REV v7 Changes  
 HAM3-4 SUS/4WLV Controls Wiring - REV v7  
 7 of the system wiring includes HAM3 and HAM4 Op Lev signal channels signal path.  
 (See page 18)

# HAM3-4 SUS Front End CPU ADC Connections

## Binary IO Connections for Contec DIO-6464L-PE Module 0

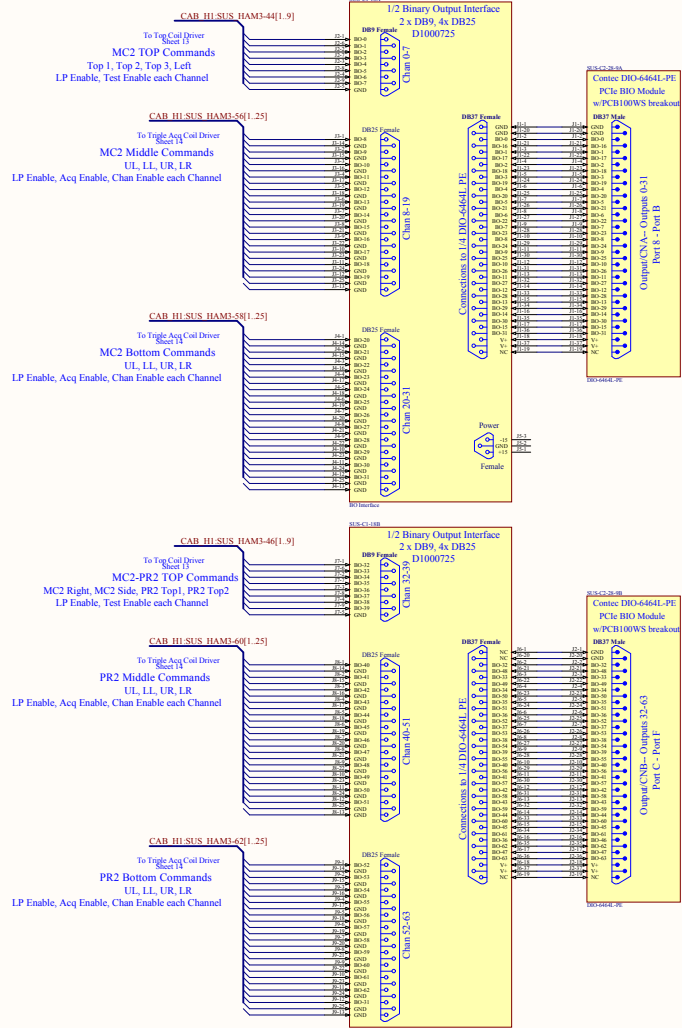
Maybe make a different special cable to get the SR2 BIO (8 chan) on this module into the 25 pin Dsub on sheet 16

## Binary IO Connections for Contec DIO-6464L-PE Module 1

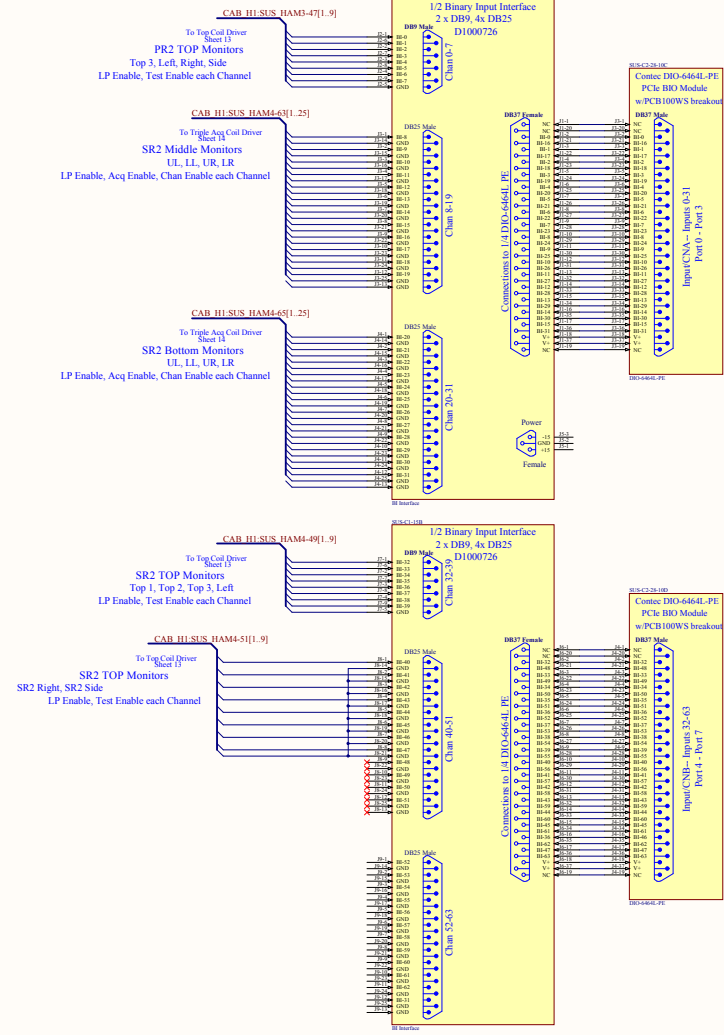
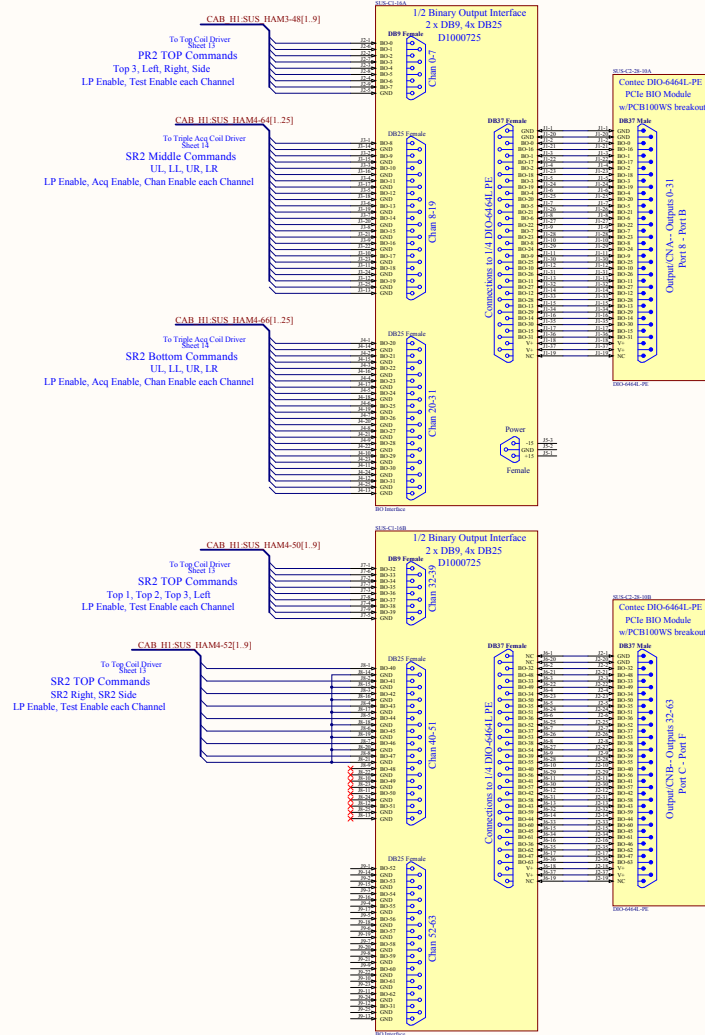
May want to rethink the bio interface for this page so that we can get second SR2 TOP BIO into modules

## Binary IO Connections for Contec DIO-6464L-PE Module 2

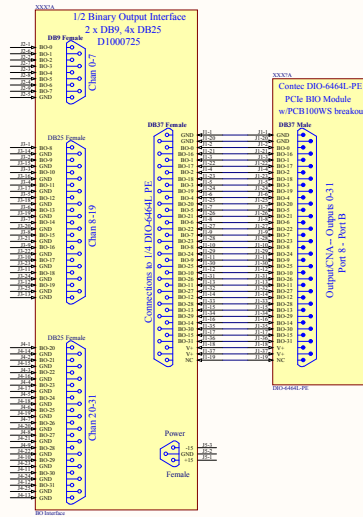
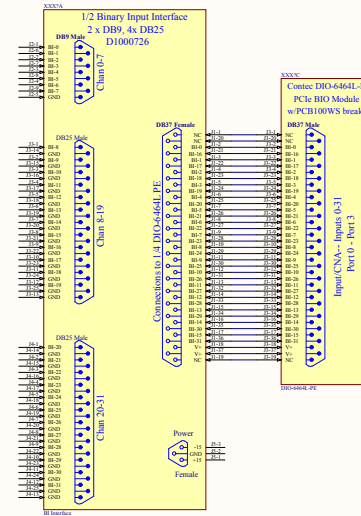
Don't need this if BIO is reworked on page 16 to handle SR2 TOP
